17th June 2010

SANDY BEACH MILL PROPOSED SUBDIVISION LOT 260 DP 1110719 GRAHAM DRIVE, SANDY BEACH

I refer to my Bushfire Hazard Assessment Report issued 11/6/2009, and provide this letter of advice as an addendum to that Report. The advice herein is in response to:

Figure 1: construction level threshold plan - replaces plan on page 27 of original Report

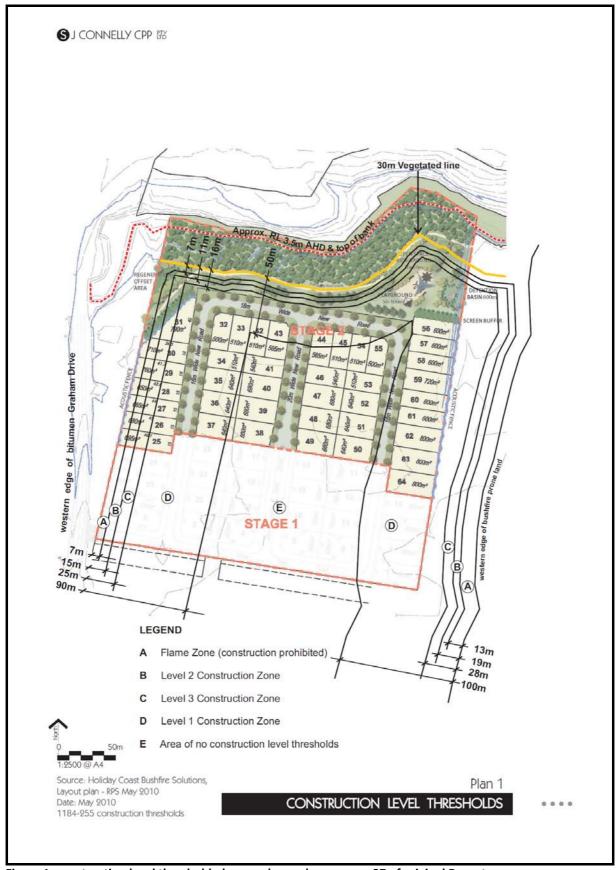
The plan on page 27 of my Report reflected the concession provided in *PBP-2006*. However, you have advised that this riparian area is to be revegetated as provided below in your e-mail dated 7/6/2010:

CHCC have agreed that revegetation of the 50m riparian buffer to Double Crossing Creek should generally be carried out such that the first 20m from top of bank is to be heavily vegetated, representative of vegetation located east and west of the site, the next 10m is to be less heavily vegetated, while the final 20m is to comprise isolated trees and shrubs with a turfed understorey.

The description of the revegetation above indicates that APZ-conditions (outer protection area) will exist at a distance of 20m from the top of the creek bank, therefore, the concession provided by *PBP-2006* will still apply. The attached plan reflects the impact the revegetation has on the construction level threshold across the site, and replaces the plan provided at page 27 of my original Report.

SR4 The construction requirements of future dwellings should be determined in accordance with the plan attached as Figure 1 to this Addendum, and the NSW Rural Fire Service "Fast Fact 02/2010 – BCA 2010 Transition".
